## EAGLE MOUNTAIN PLANNING COMMISSION MEETING

**December 12, 2023, 5:30 PM**

##### **1.A [CONCEPT PLAN/DISCUSSION - Gardner Farms](#)**

## MASTER DEVELOPMENT PLAN

[Quaillhill Stake temp site](#)

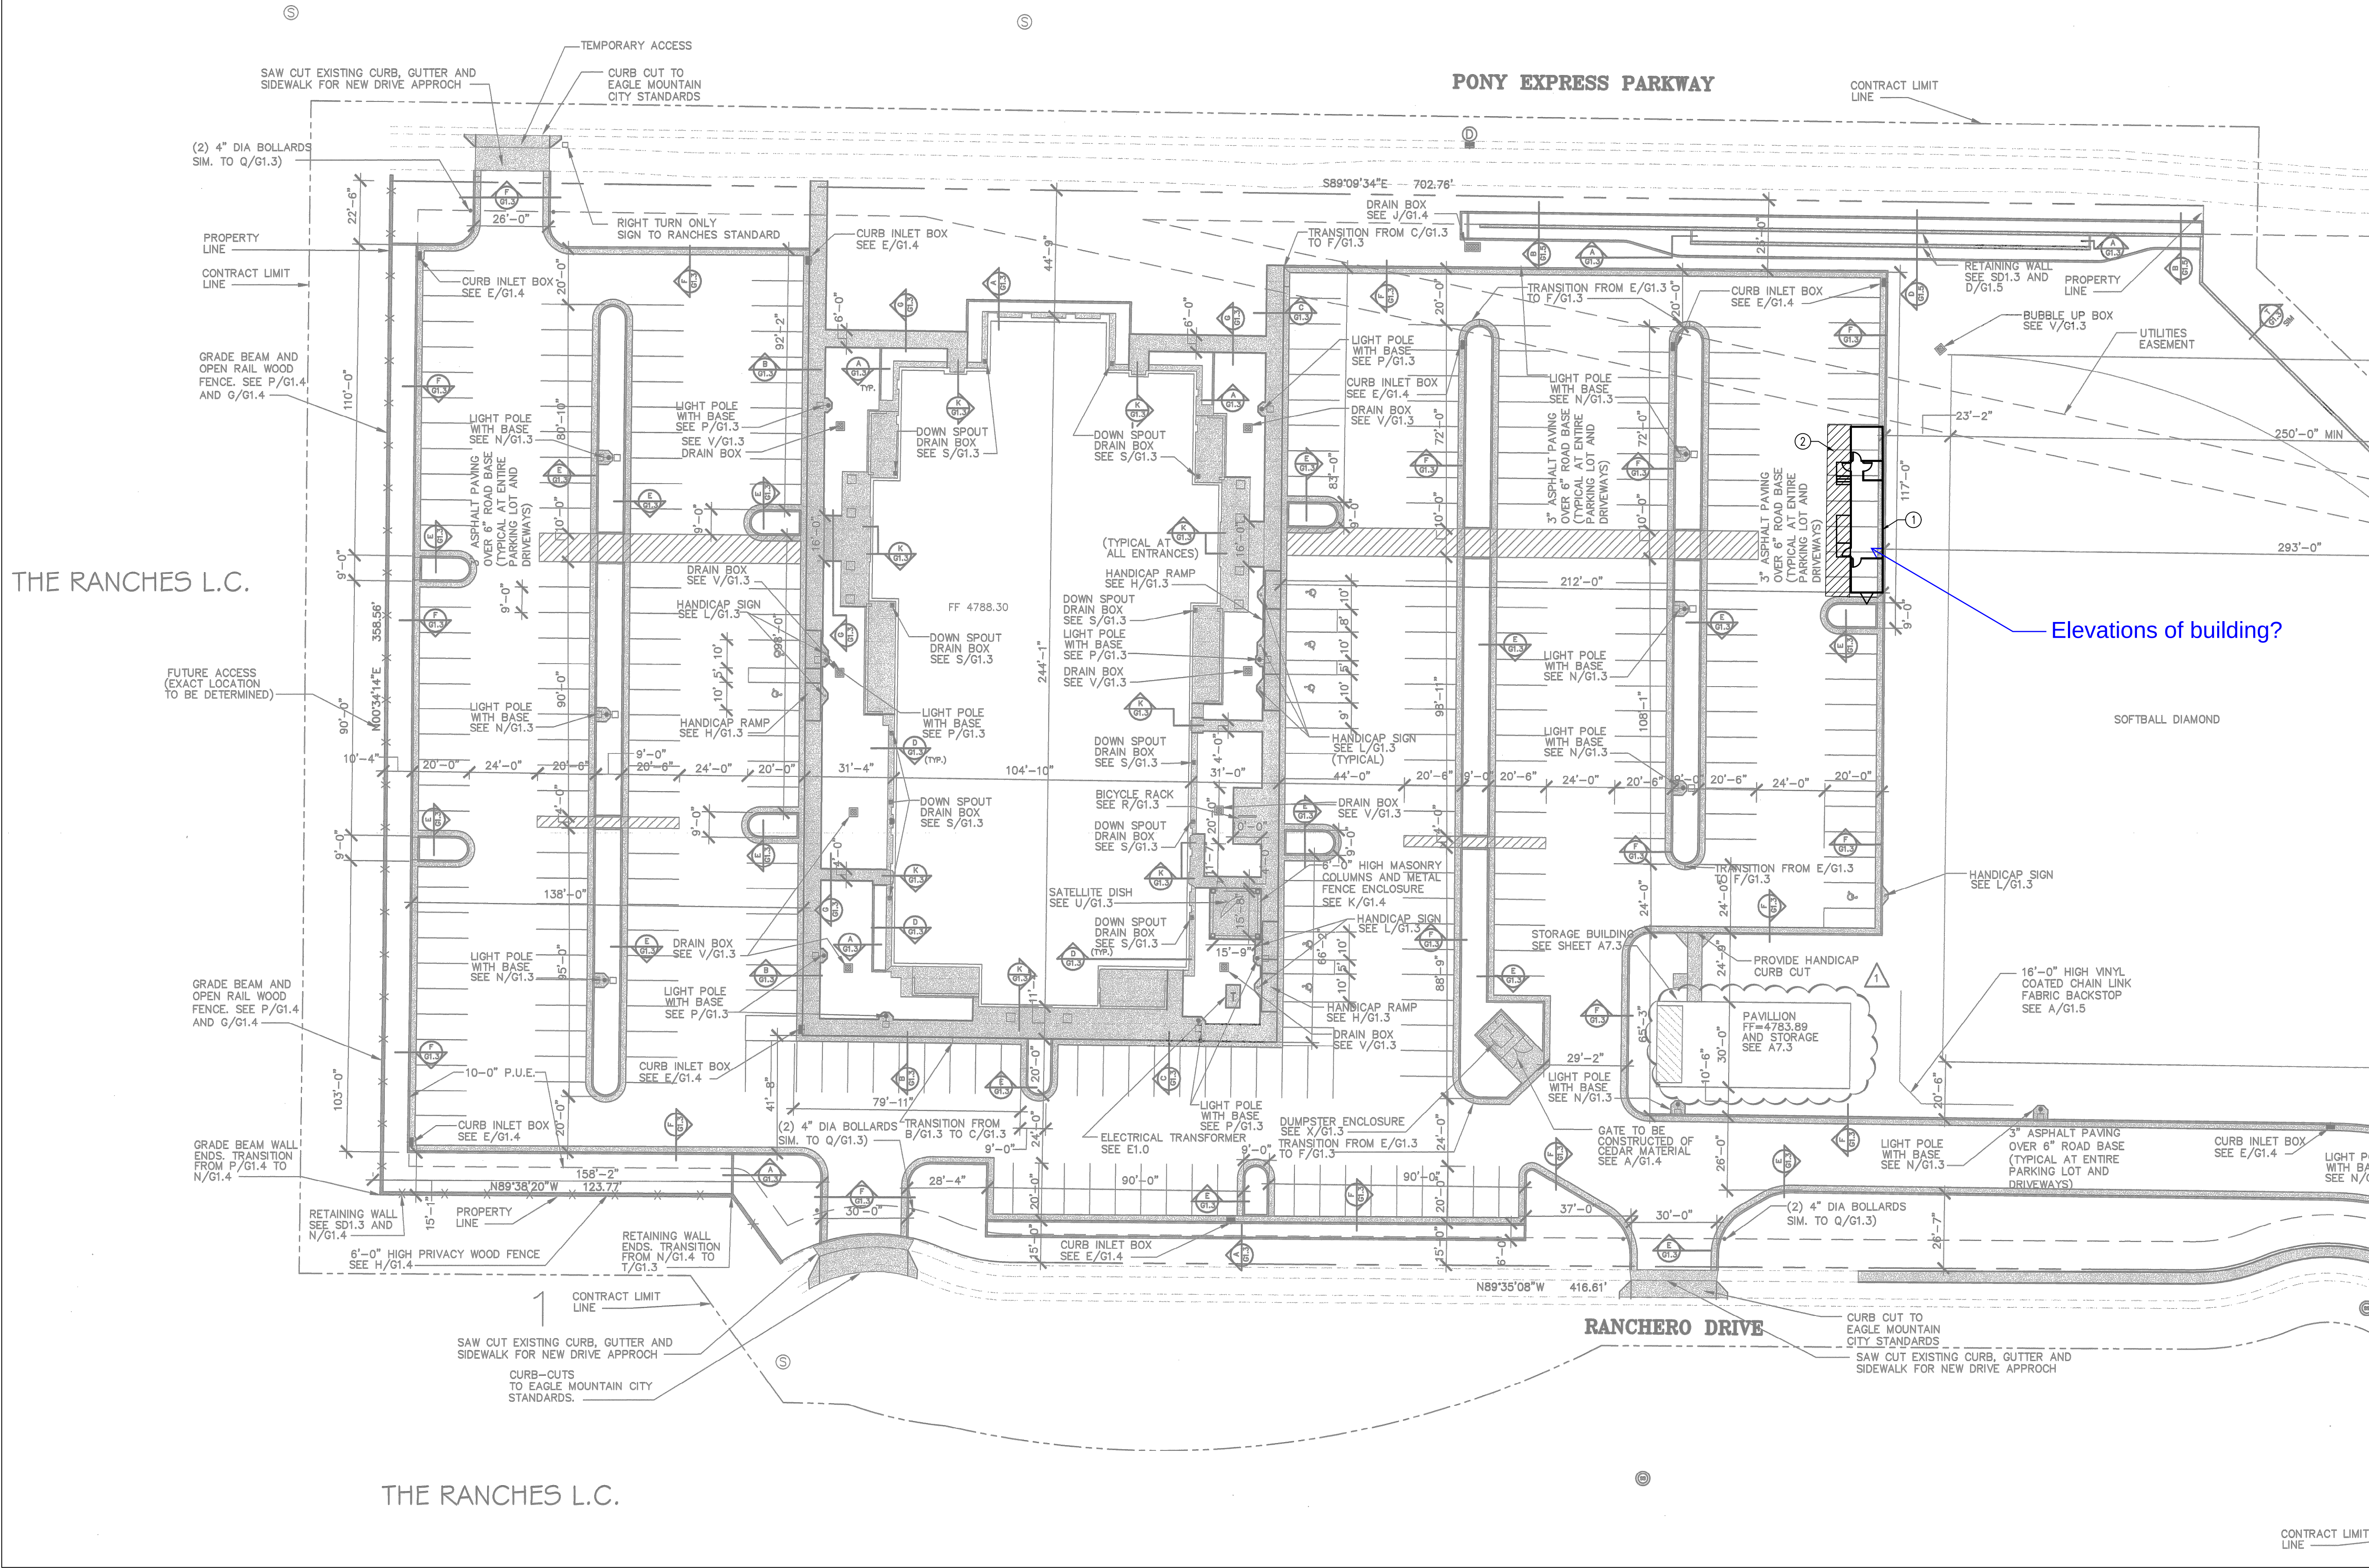
1. Submit elevations of the temporary structure.
